PCN – Process Change Notification

Change:	ISA.06.A.301111
Date:	2016/04/27
Author	Haley Tsai

Model#	Part Number	Changes
400~470Mhz I-Bar Adhesive ABS Mount Antenna with 3M RG-174 SMA(M)	ISA.06.A.301111	1. Correct marker 2 to 3
		2. Amend P/N to ISA.06.A.301111.
		3. Amend SMA tolerance.

Illustration of Change (ISA.06.A.301111)

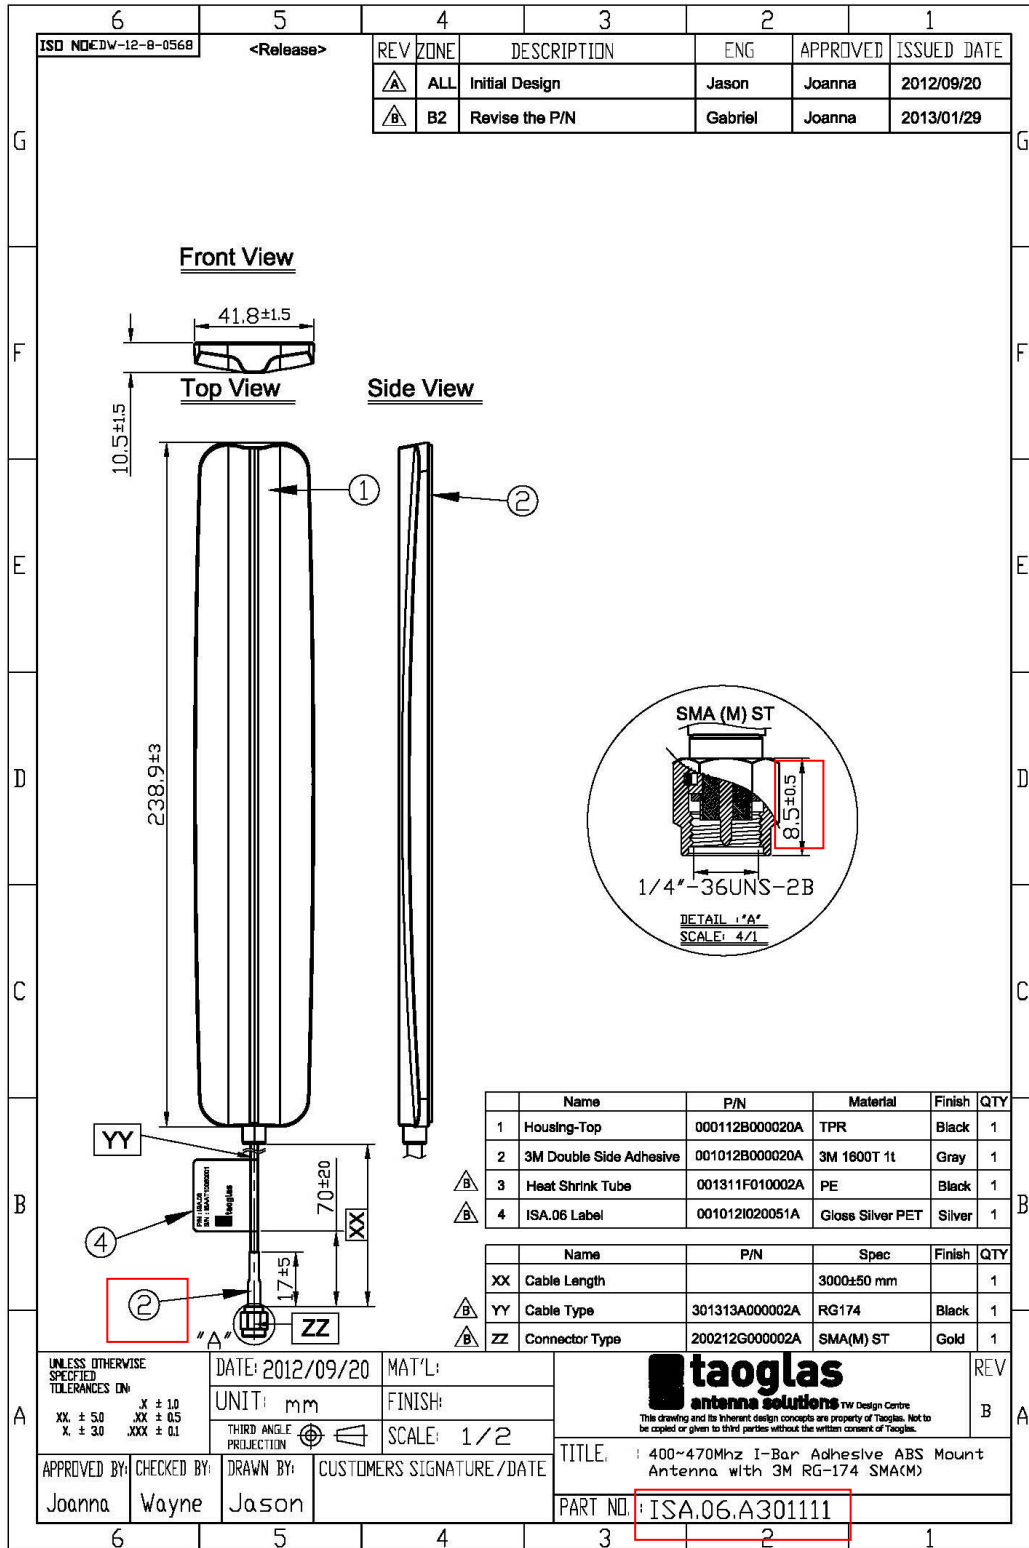
1. Correct marker 3 to 2 to match BOM.
2. Amend incorrect part number to ISA.06.A.301111.
3. Tolerance for SMA changed from +/-0.5mm to +/-0.3mm according to SMA drawing.
